**April 25, 2025
Addendum #2
FOR IMMEDIATE ATTENTION**

Reference – Invitation for Bid:	IFB #018-0-2025/SB Heritage High School Main Distribution Switchboards Replacement
For Delivery To:	Newport News Public Schools
Bids Due:	May 8, 2025 at 2:00 PM EST

ADDENDUM NO. 02

**Heritage HS Switchboard Replacement
Newport News Public Schools
IFB Project No. 018-0-2025SB
Newport News, Virginia
TCE # 21-163**

Heritage High School PV Interconnection Specification

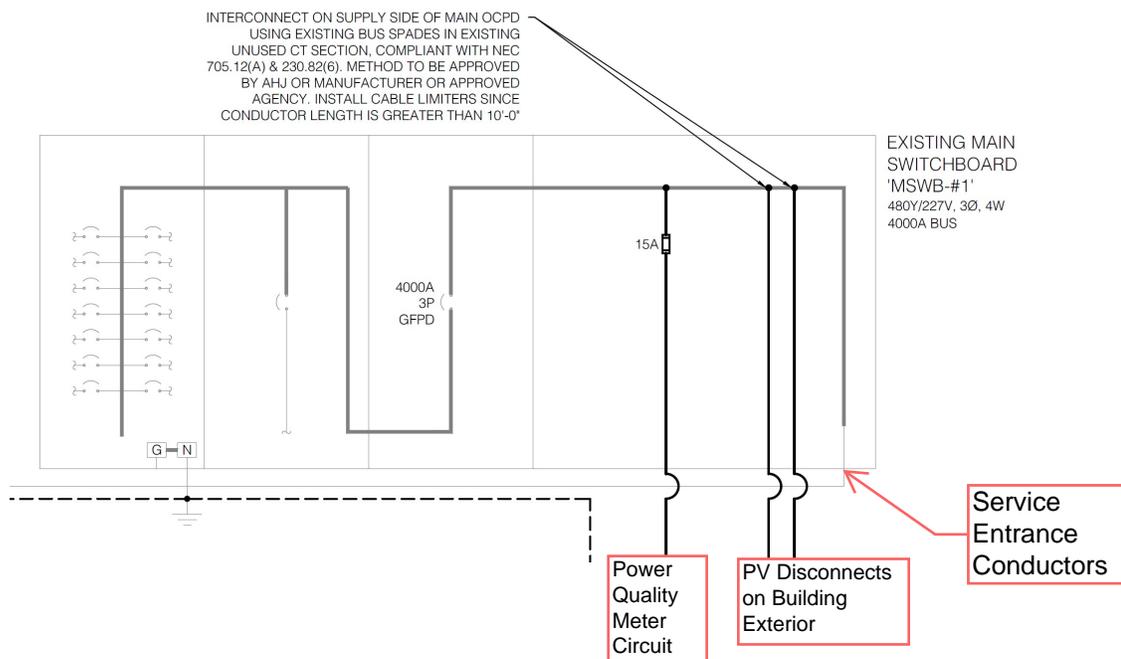
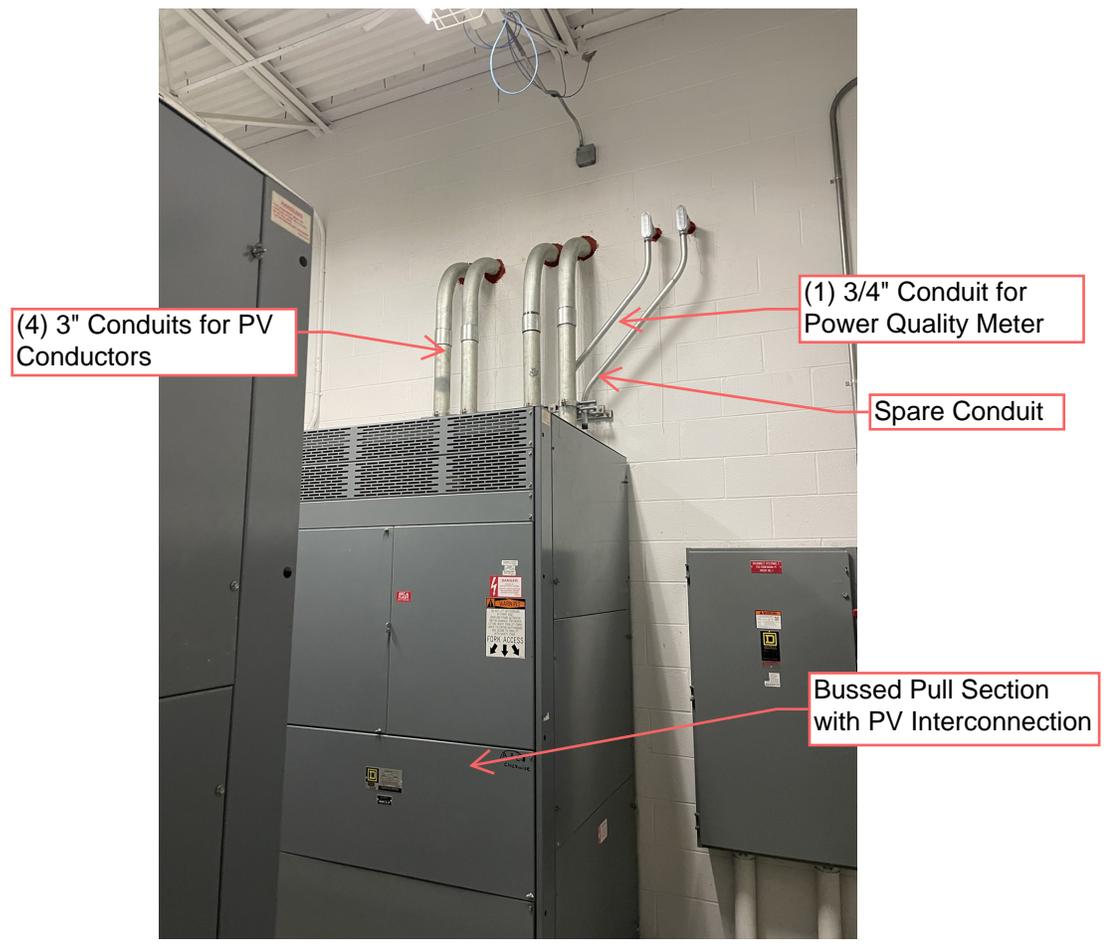
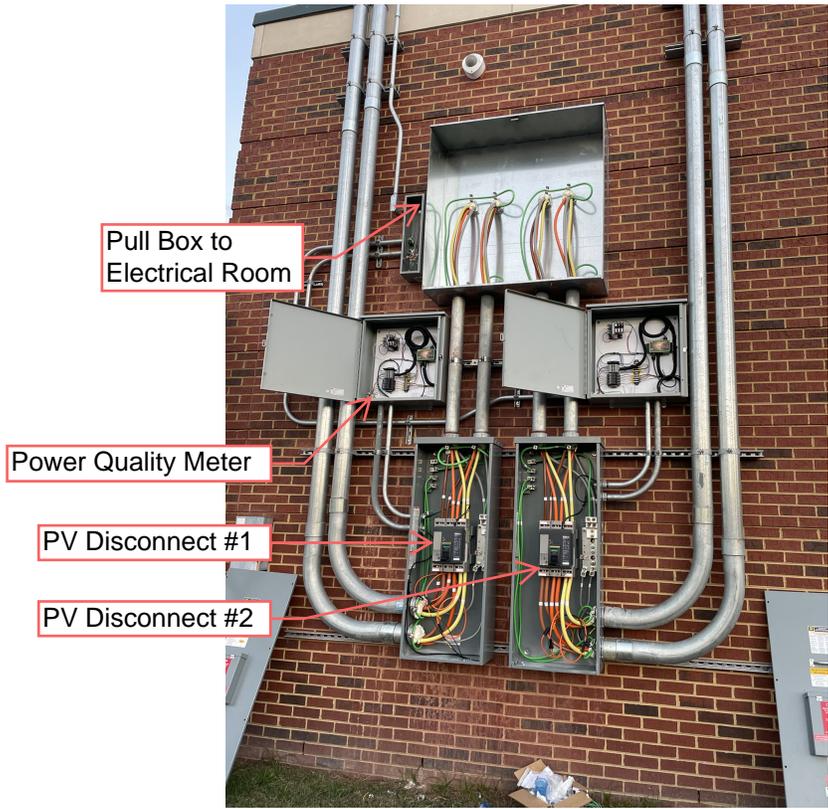
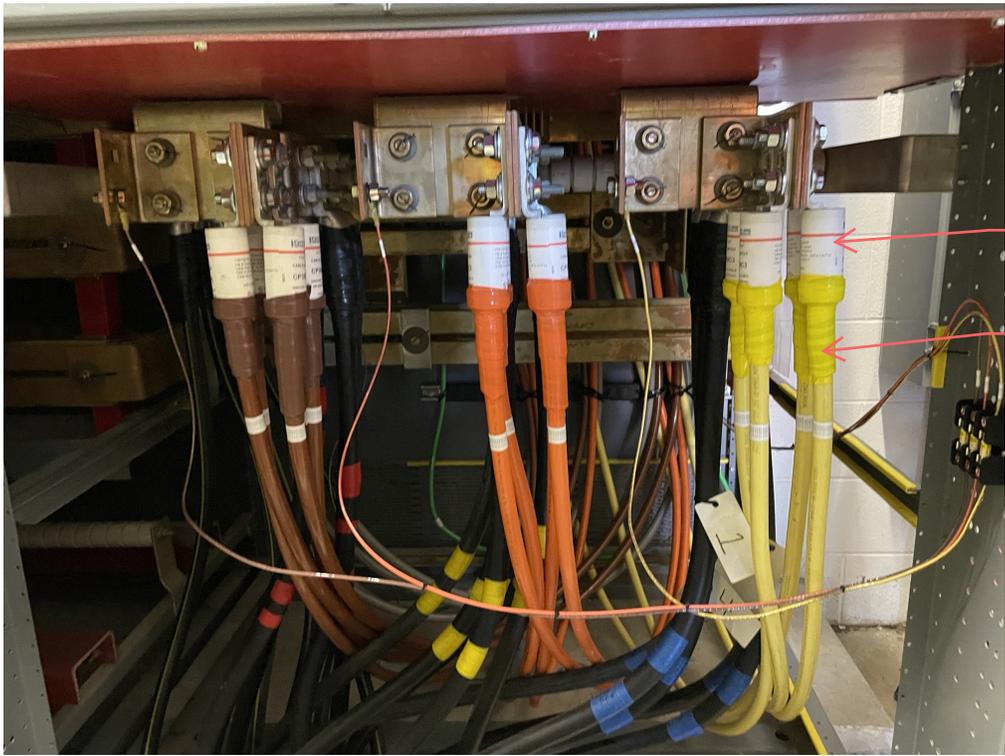
The 720kW PV system at Heritage High School terminates in the bussed pull section of the 4000A switchboard on the supply side of the main breaker. For the replacement of the switchboard, it is recommended that this supply-side interconnection method be maintained to ensure compatibility with existing PV conductors, cable limiters, and system layout. There are two 600A PV system disconnects and one Power Quality Meter circuit on the exterior of the building that are fed into the electrical room. Refer to As-Built electrical set for full system details.

- (4) sets of 350 kcmil CU THWN-2
- Each terminated with cable limiter
 - Includes NEMA 2-hole tongue for connection to copper bus
- Bolt stack shall include:
 - Grade 5 hex bolt
 - One flat washer (hardened steel or tin-plated copper) and one Belleville washer (spring washer, high-carbon steel alloy AISI 1074 or equivalent) per bolt
- Conductors shall be reused and re-terminated in the new switchboard as shown in the existing configuration

- (4) 350 kcmil CU THWN-2 conductors
- Terminated with UL-listed compression lugs (2-hole NEMA pattern)
- Connected to the neutral bus using grade 5 hardware with flat washers
- Conductors shall be reused and re-terminated in the new switchboard as shown in the existing configuration

- (2) 2/0 CU THWN-2 conductors
 - Terminated to the ground bus using UL-listed compression lugs with 1-hole tongue
 - Each secured with a flat washer and torque-marked bolt to ensure proper mechanical and electrical contact
-

- Conductors shall be reused and re-terminated in the new switchboard as shown in the existing configuration

Cable Limiters

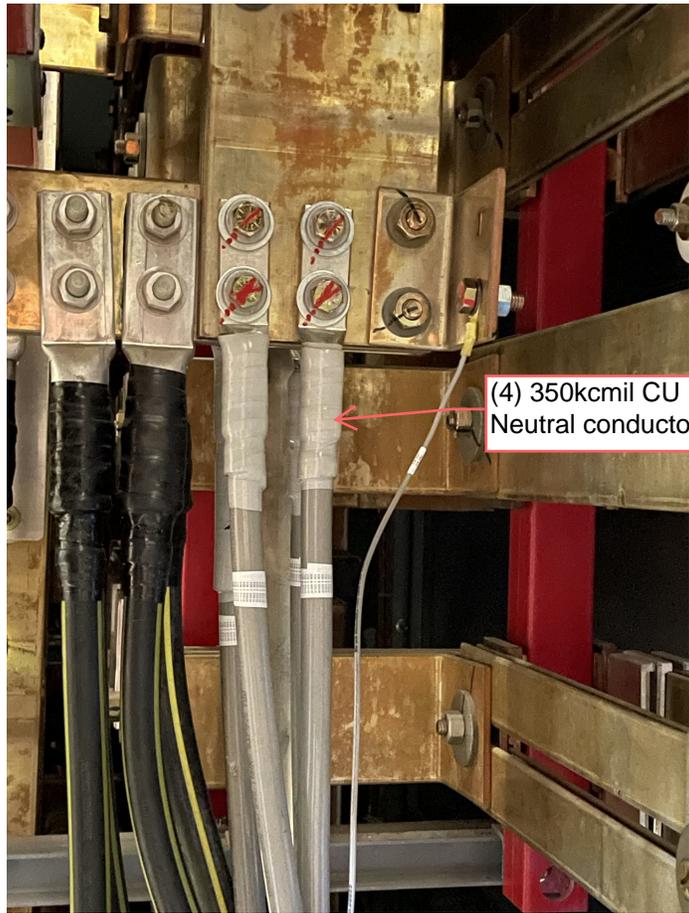
(4) 350kcmil CU per phase

(4) 350kcmil CU Neutral conductors

(2) GEC connections -
1 for each PV
disconnect.

Power Quality Meter
Grounding Conductor

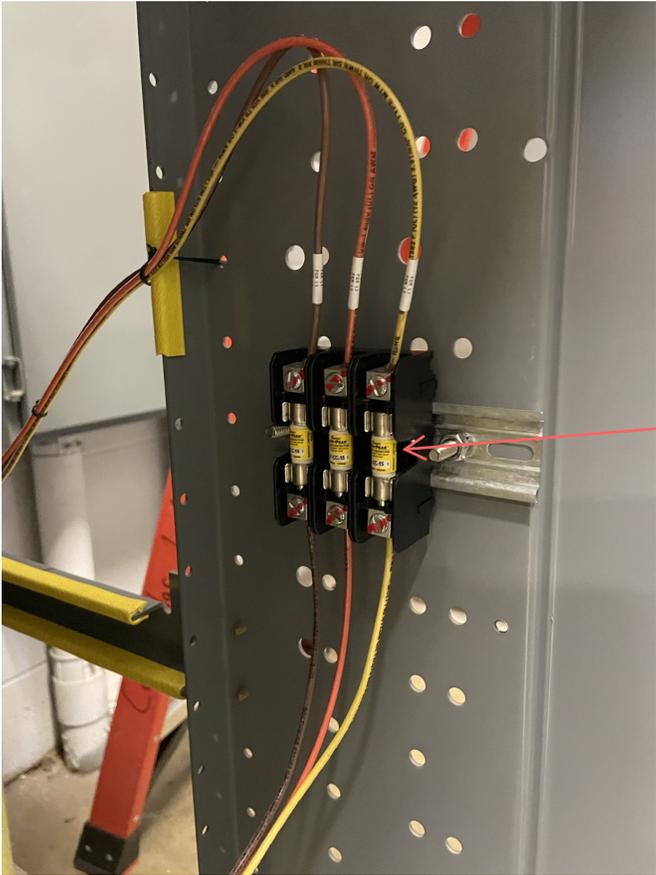
15A Fuses - DIN rail
mounted for Power
Quality Meter Circuit
